12 Elevations and Materials

12 Elevations and Materials: Amendment Response

Fig 28 Extract of Section 5.8 of the originally submitted Design and Access Statement - Elevations and Materials

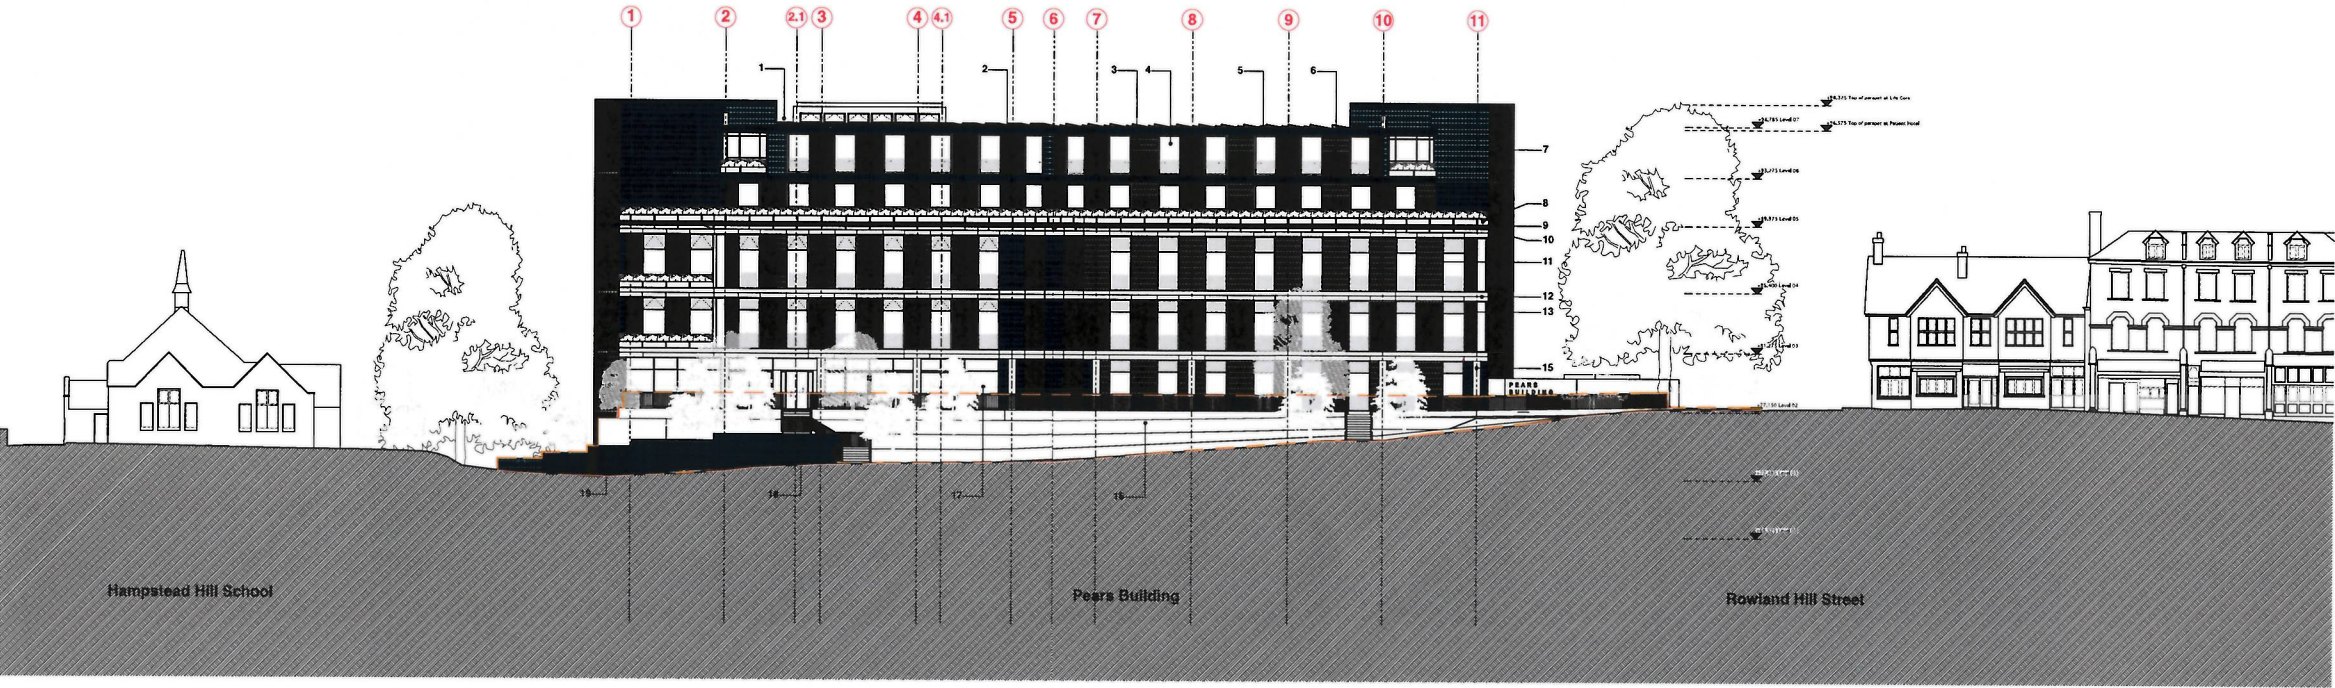
There are no changes to the building or its arrangement as part of this proposed amendment. The only element removed from the building itself is one external canopy on the North elevation, which is made redundant through the changes in the lift access arrangements (Refer to Section 6: Landscape Masterplan).

The layered approach of the external terraces is retained and it mimics the layered approach to the building's facade.

The reflection of the 'cranked plan' in the arrangement of the external terraces is also retained.

Fig 31 Proposed Amendment - Elevations and Materials

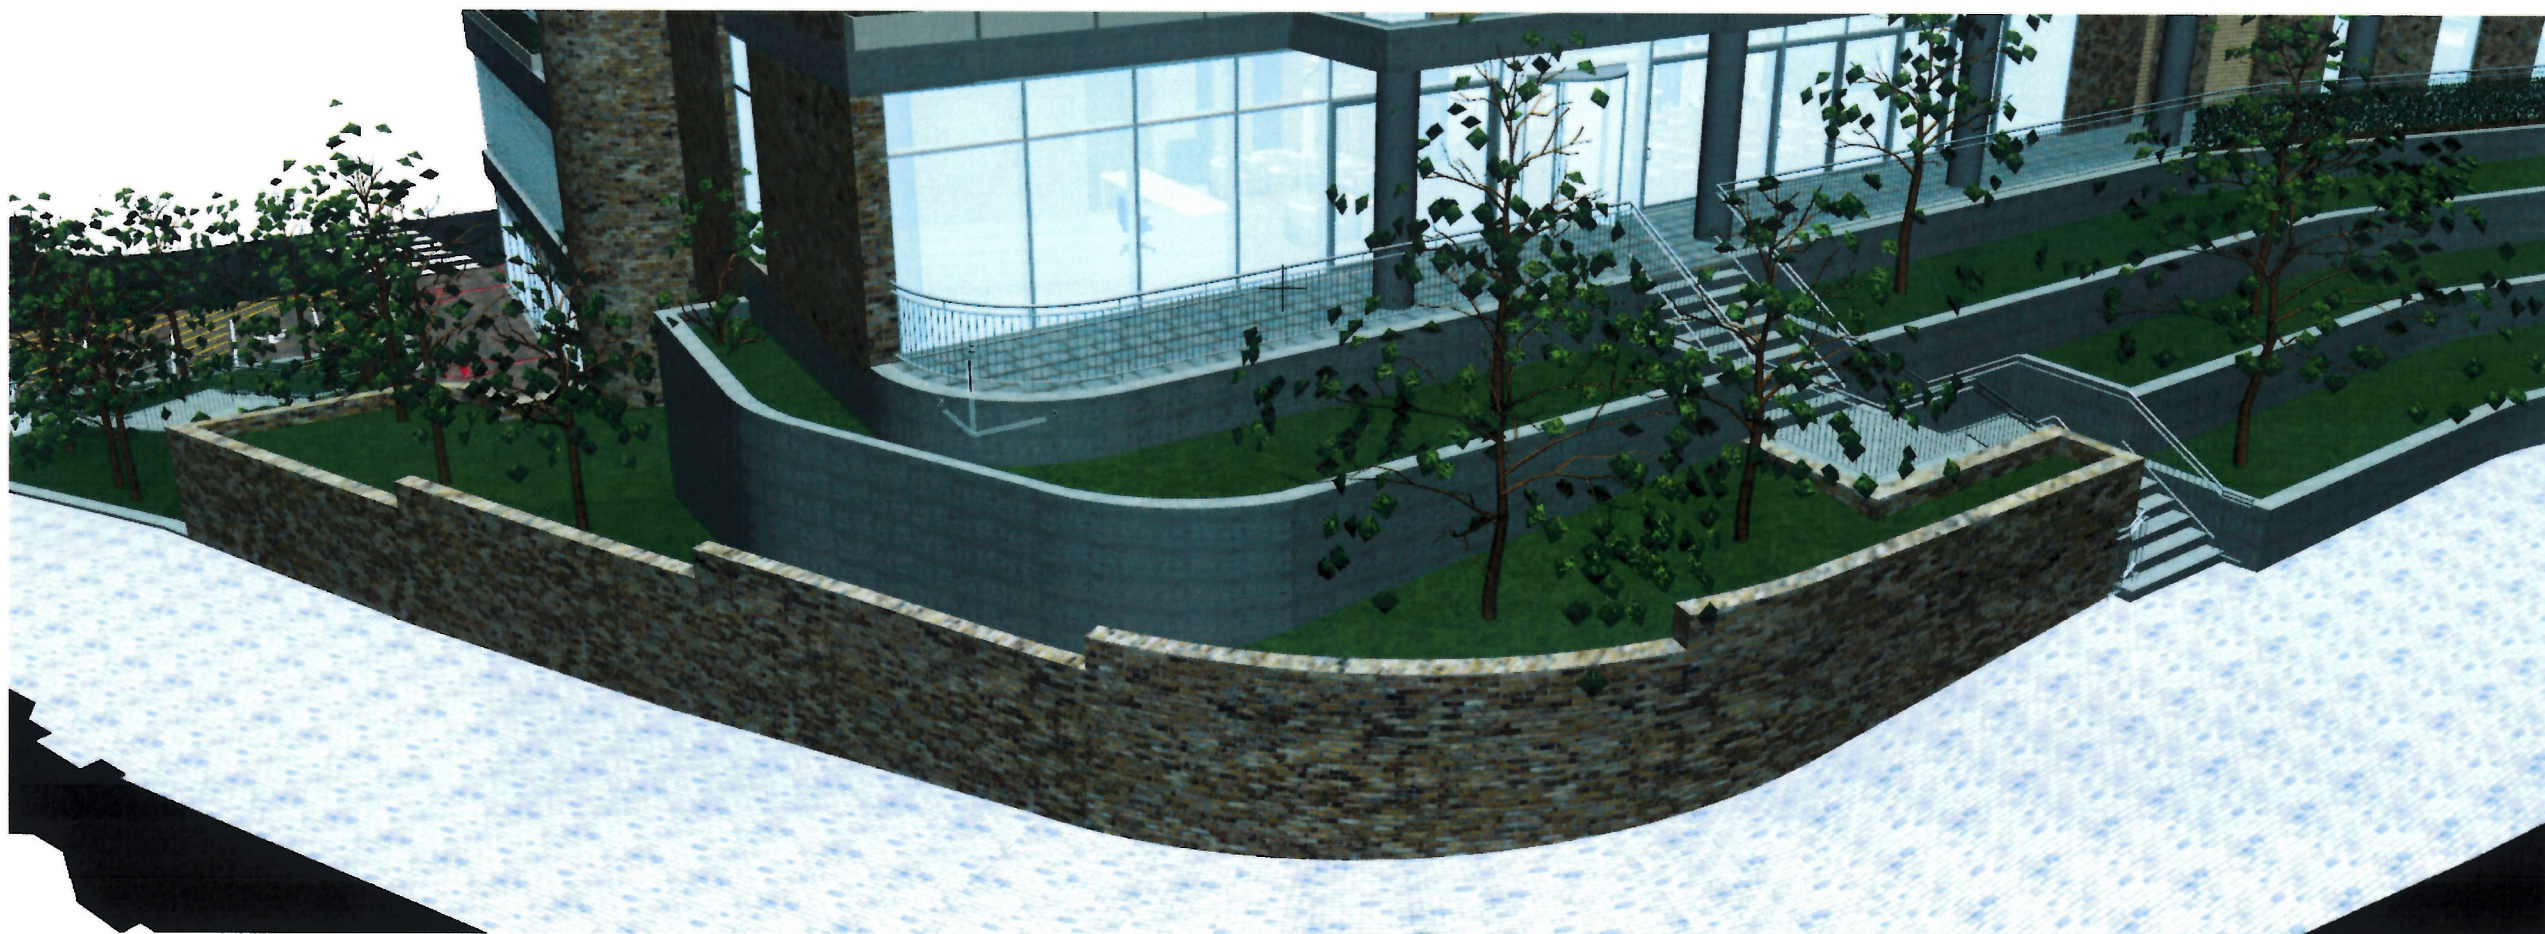
There are no changes to the building or its arrangement as part of this proposed amendment.

The planting concept of the landscaped terraces remains unchanged.

The proposal to use brick on the retaining wall to the North- West corner remains unchanged in this amendment. The only changes constitutes in adding a few "steps" to the already staggered arrangement of this wall.

The proposed landscape redesign aims to return the public footpath to its existing footprint as closely as possible, maintaining the minimum existing width in all locations.
